ADDENDUM NUMBER ONE

Date: March 17, 2016

Re: UNC Charlotte – Residence Dining Hall Renovation
SCO ID: 14-11273-02A
JPA Project #: 15NCC491

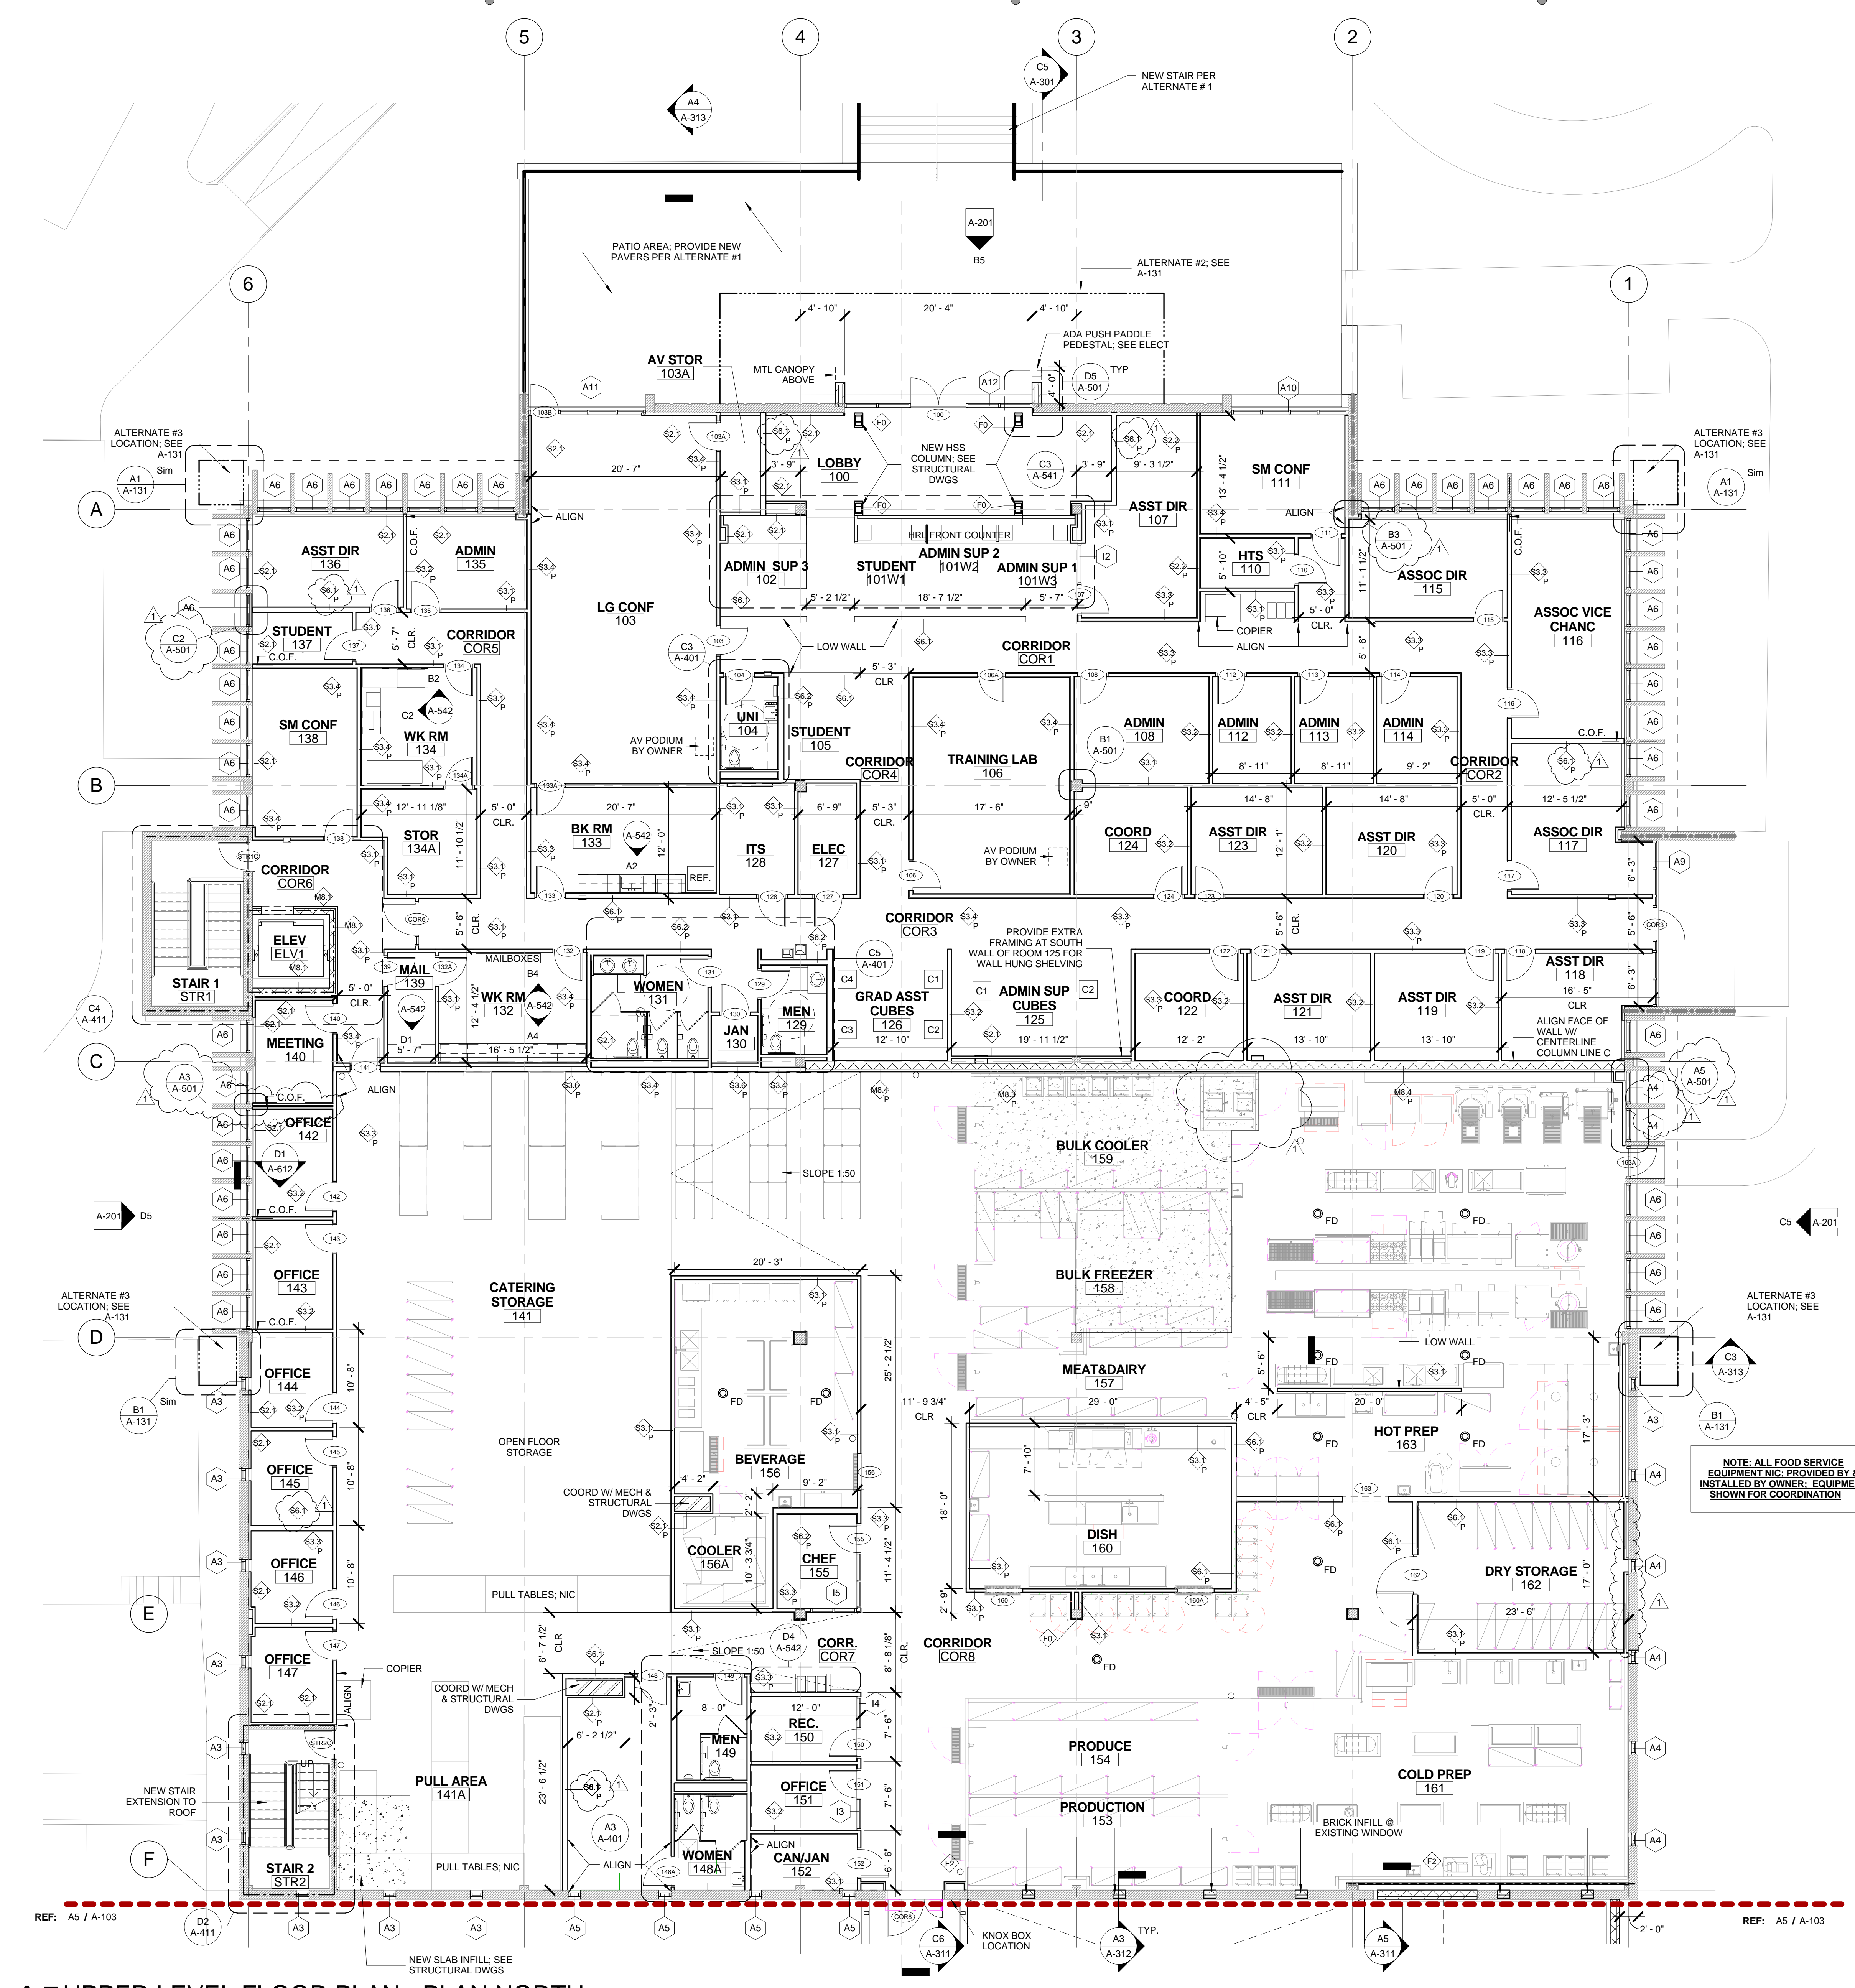
- Item 28. Architectural Drawing Sheet A-102 – Replace drawing sheet A-102 UPPER LEVEL FLOOR PLAN in its entirety with included new A-102. Modifications include but are not limited to:

- A. Modification: enlarged details have been added
 - B. Blast chiller location modified
 - C. See plan for newly modified wall types
 - D. Modification: Dry Storage 162 east wall new furring added to accommodate roof drain leaders

- E. Clarification: Note added: “New recessed slab location; see structural dwgs”
- Item 29. Architectural Drawing Sheet A-401 – Replace drawing sheet A-401 ENLARGED RESTROOM PLANS & DETAILS in its entirety with included new A-401.

**PLUMBING
SECOND
LEVEL PLAN
NEW WORK**

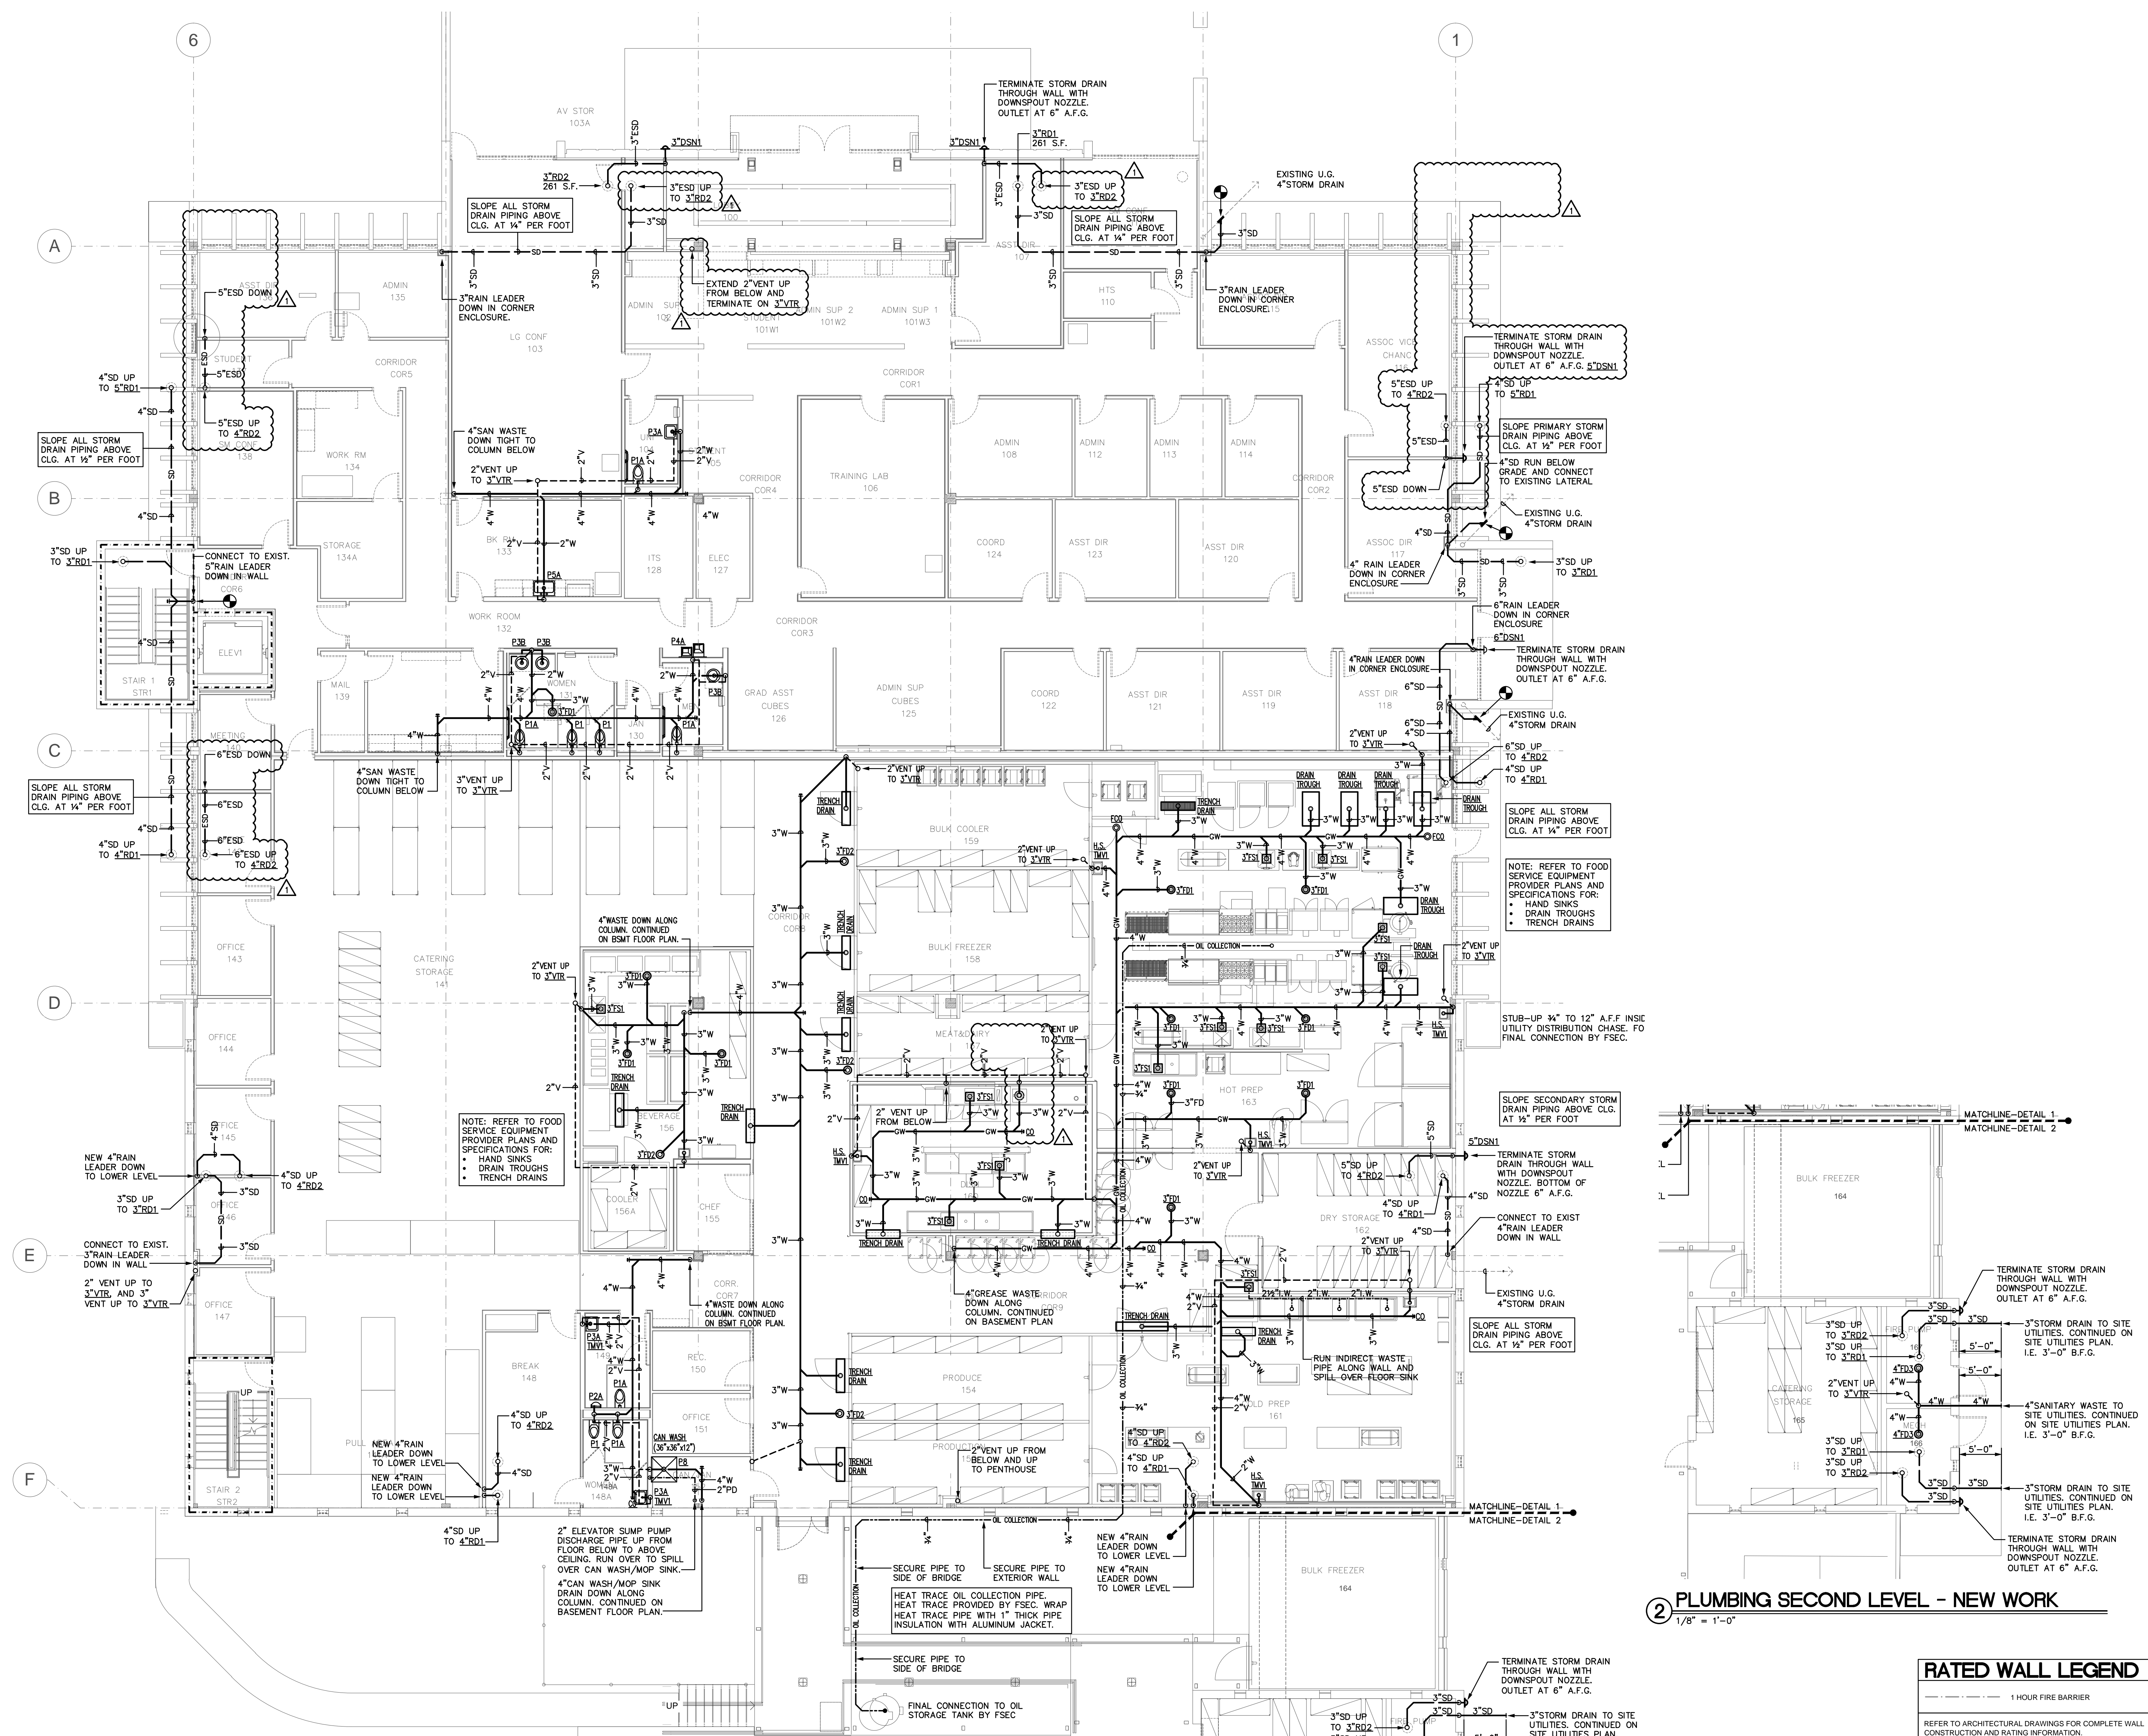
- L. Bidder Question: Please clarify make and model of SS-1. There appear to be two sizes both labeled SS-1.
- Designer Response: The small SI1 that was shown in room Dish 160 has been deleted, revised plan P202 is included in Addendum 1. The only Solids Interceptor to be provided

is SS1 located outside, just upstream of the grease trap (GT1). It is as specified on drawing P003, Interceptor Schedule. This sheet is included in Addendum 1 as well.
